Detroit River
INTERNATIONAL CROSSING
S T U D Y

Value Planning Workshop for

the Proposed
Detroit River International Crossing

February 2, 2007

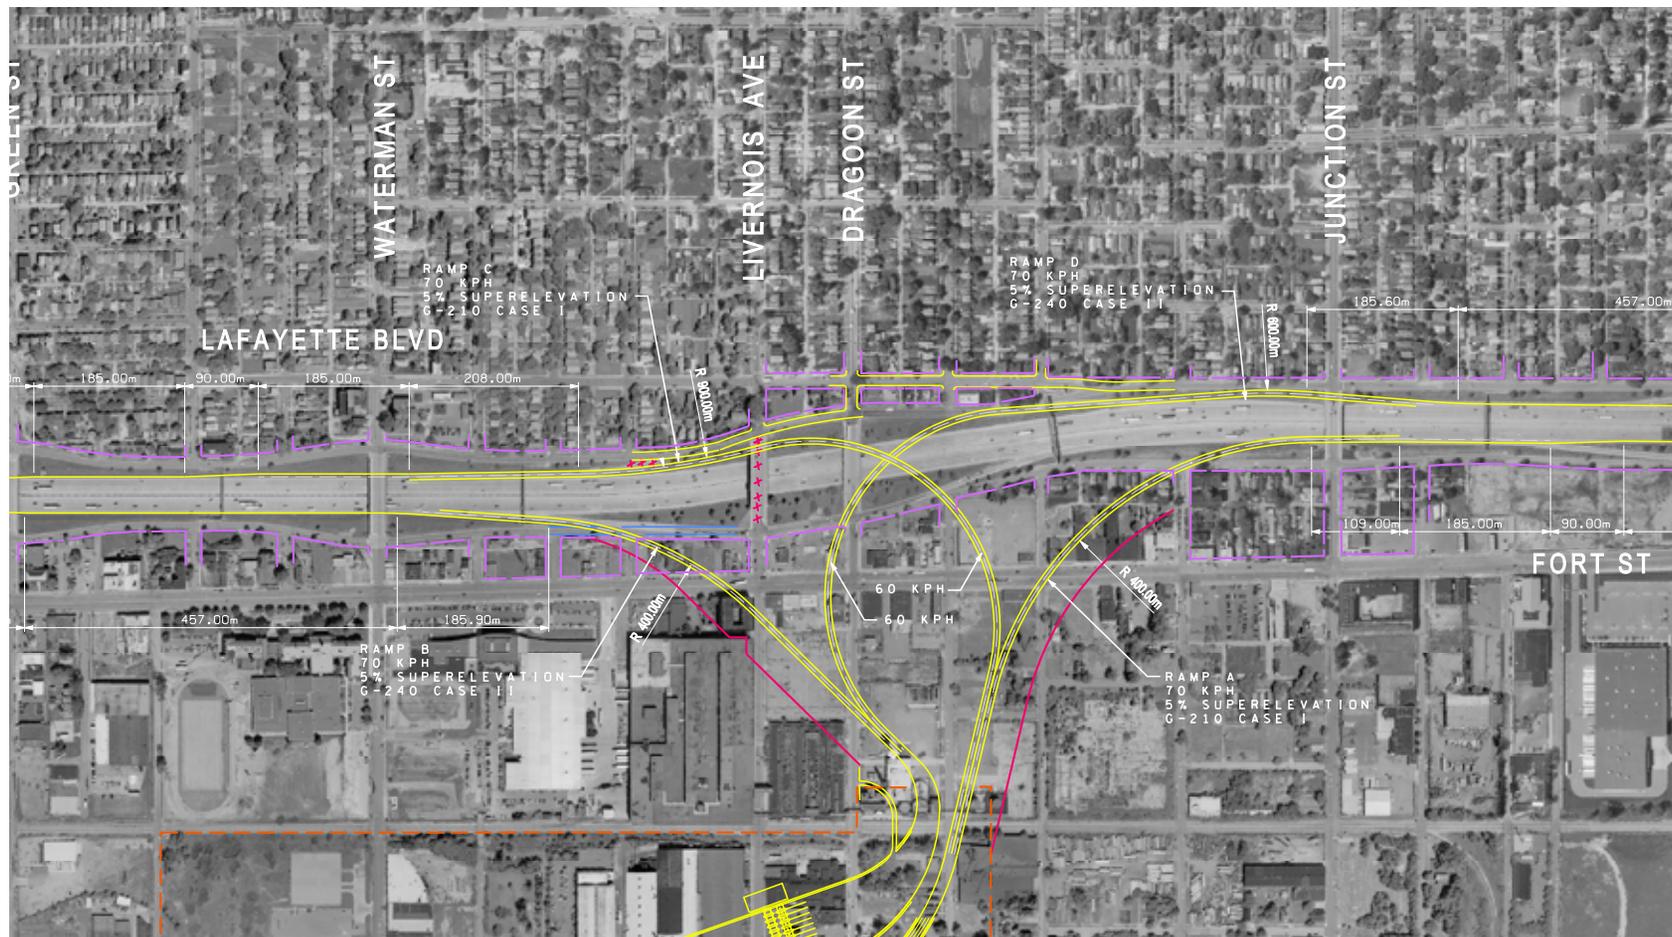
- Maintains Clark and Springwells Interchanges
- Localizes the impacts to service drives
- Requires less Right-of-Way
- Reduces impacts north of I-75
- Slows traffic entering the Plaza

- Design Speed of 30 mph in circle
- Close Livernois Bridge
- Close Livernois / Dragoon Interchange

The exits and entrances around Waterman St. and Junction St. will follow the applicable MDOT Standards and would be able to provide the required acceleration and deceleration distances. The exit and entrance ramps to and from the I-75 freeway will be designed to 70 kph (45 mph). However, within the circle, the proposed interchange has a minimum radius of 150 meters with a corresponding design speed of 50 kph (30 mph) for a 6% superelevation design (Based on MDOT Standard R-107-D1, page 1).

Due to the need to decelerate and stop before entering the Plaza, it is assumed that this configuration could work with the minimum radius of 150 and still provide a free flowing traffic. Further traffic studies can be performed to determine the viability of this geometry.

VP Interchange 1 requires the closure of the Livernois/Dragoon interchange and the closure of Livernois Ave. Bridge. The SB entrance to I-75 from Livernois and the NB Exit to Livernois are also closed. Dragoon St. can be kept open by raising the SB entrance ramp (Ramp C) and the SB exit ramp Ramp D that both go over I-75. The initial plan is to let Ramp D go under Ramp C and both ramps are over I-75 and Dragoon St. Profile investigations and

1. **New Interchange Concept VP1 at I-75: Circular Interchange**
Accept for Further Study
This is a circular multi-level full-movement interchange approximately opposite Dragoon Street, that retains the current adjacent Clark and Springwells interchanges. A short segment of SB Service Road could be added to the VE interchange to restore SB Service Road continuity. A variety of public or private uses could be made of land within the circle ramps.

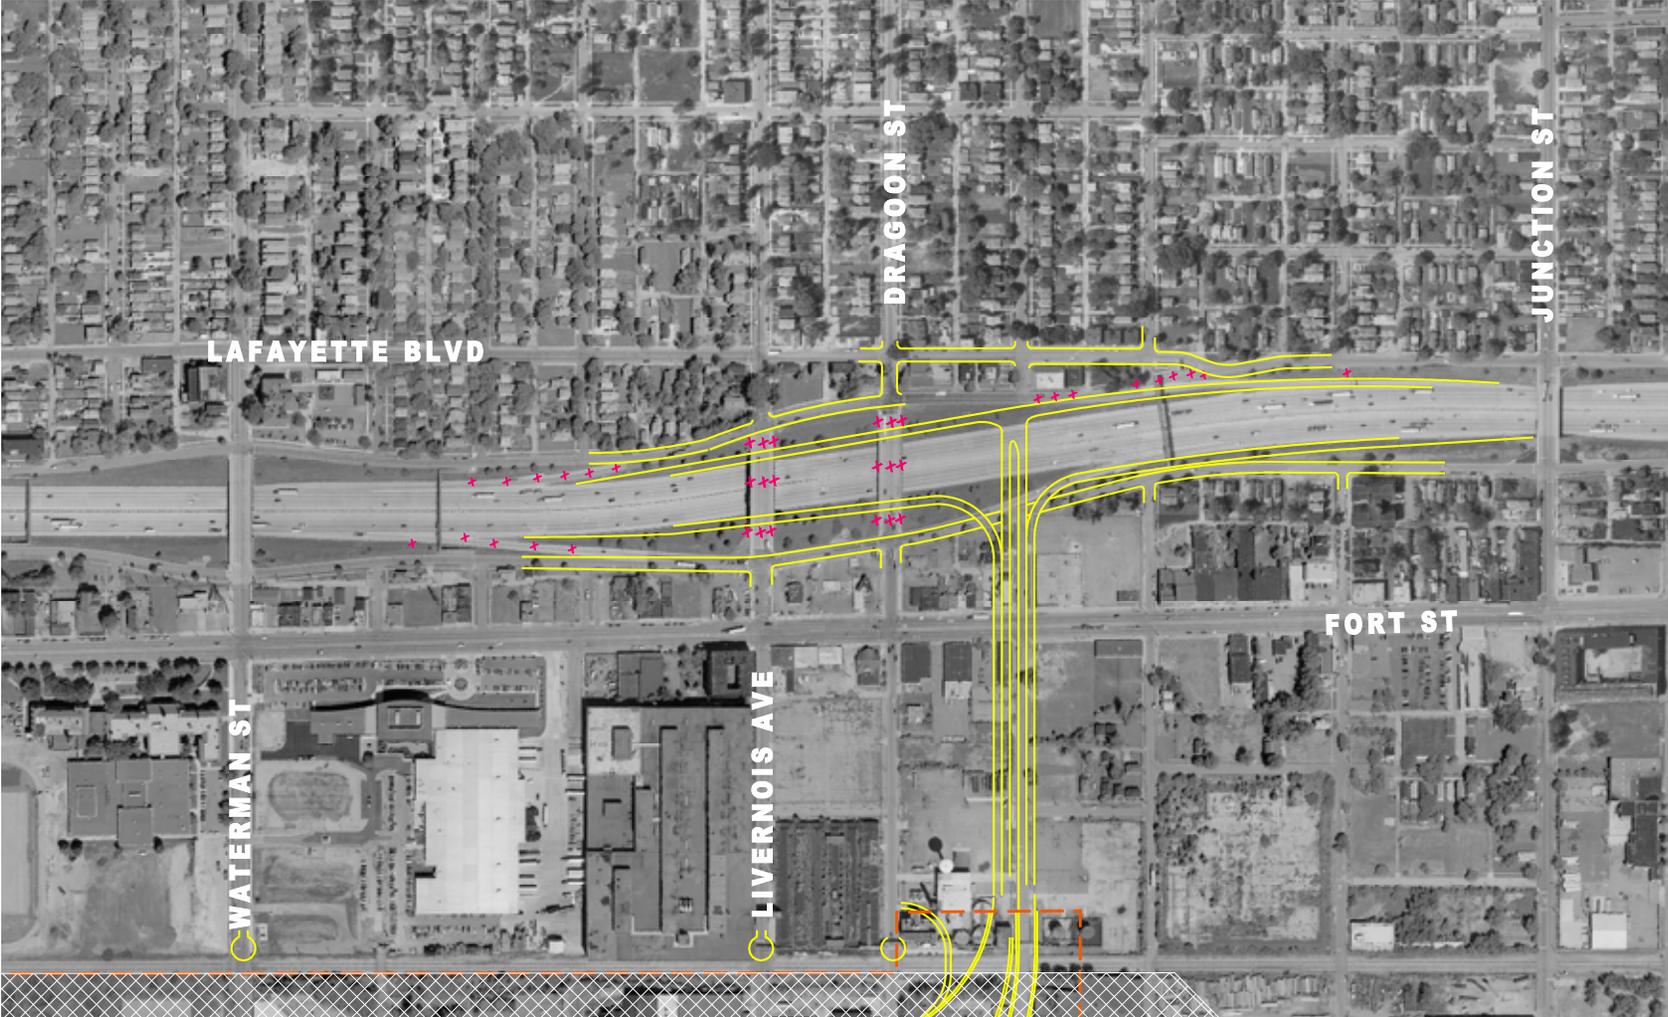
The proposed VP Interchange 2B is a variation of VP Interchange 2A except that the NB service drive goes under the ramps to and from the plaza. As such VP Interchange 2B has the same advantages and disadvantages as VP Interchange 2A with the exception that only one signal will be required for 2B.

- Maintains Clark and Springwells Interchanges
- Localizes the impacts to service drives
- Requires less Right-of-Way
- Reduces impacts north of I-75
- Localizes impact to Delray
- Less Bridge Area
- Reduces bridges over Fort Street.

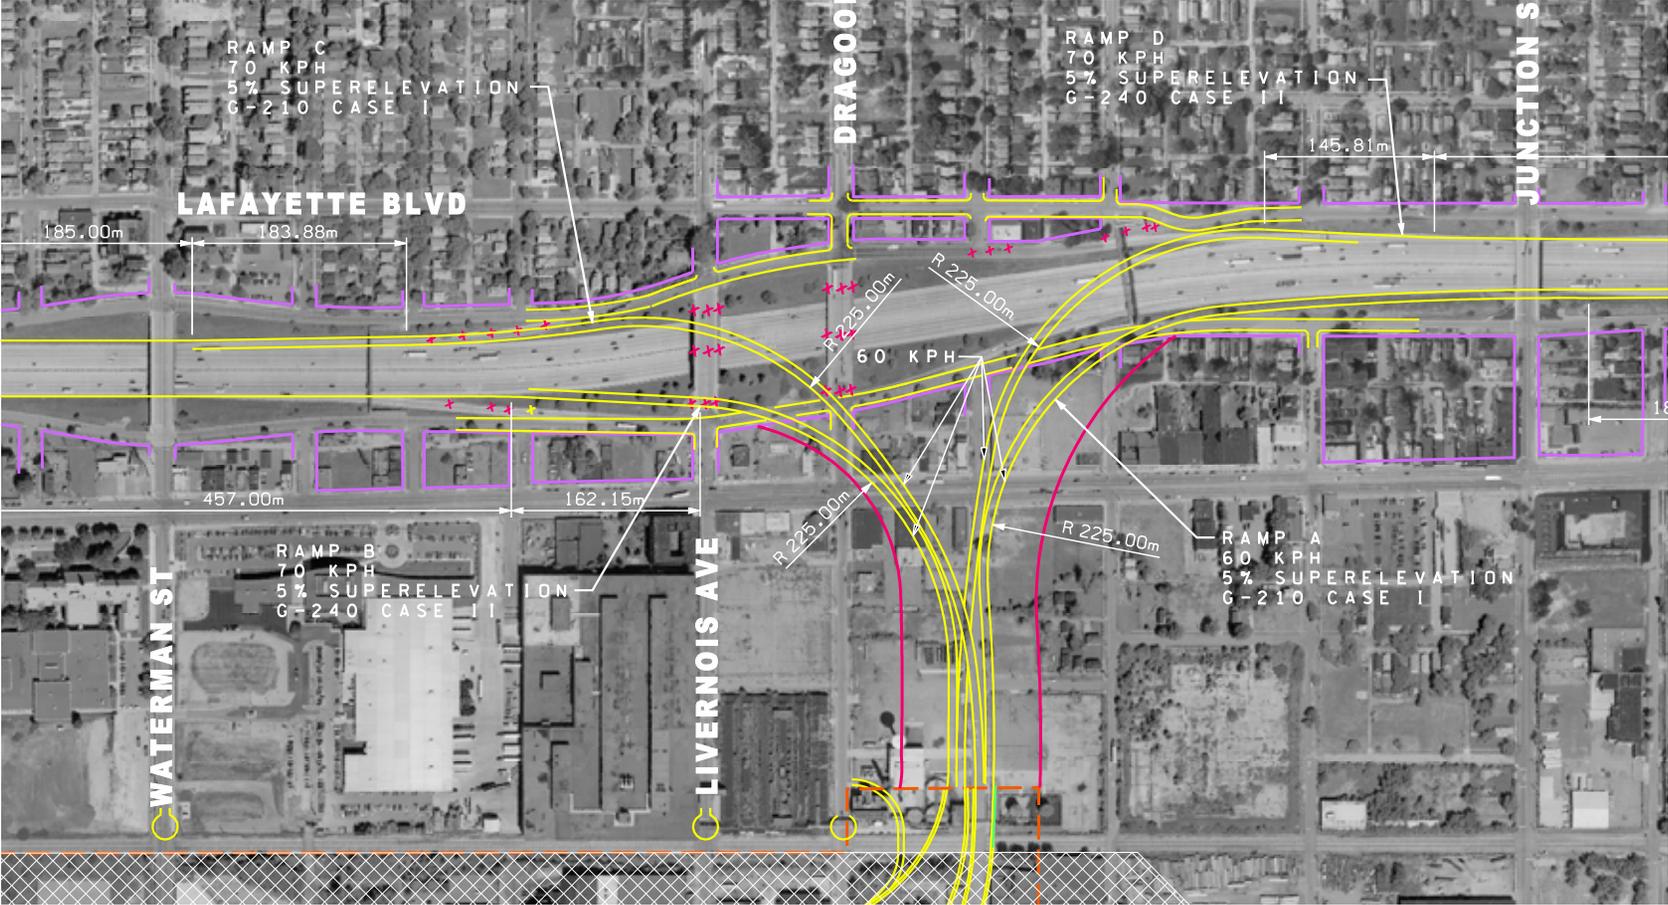
This interchange provides a free flowing traffic utilizing minimum radii of 120m and braiding the ramps to and from the plaza. It is believed that the radii can be increased to 150m to provide a 30 mph design speed.

It is assumed that this configuration could work with the minimum radius of 120 to 150 meters and still provide a free flowing traffic. Further traffic studies can be performed to determine the viability of this geometry.

Other entrance and exit points to the service drives will have to be investigated.

Profile investigations and other geometric calculations need to be performed to validate this alternative.

Exhibit 8.1

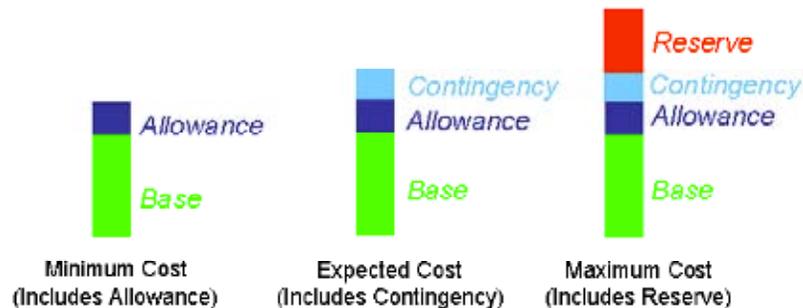
The VE Team suggests that the Cost Model for the DRIC Interchange use the ASTM Standard Classification for Allocated Sums in Construction.

This model organizes the cost of the project into four categories; base cost, allowance, contingency and reserve. These cost categories are defined by the probability of being spent and the reliability of the knowledge upon which the costs are based. The categories are shown in Exhibit 8.1 and are defined as follows:
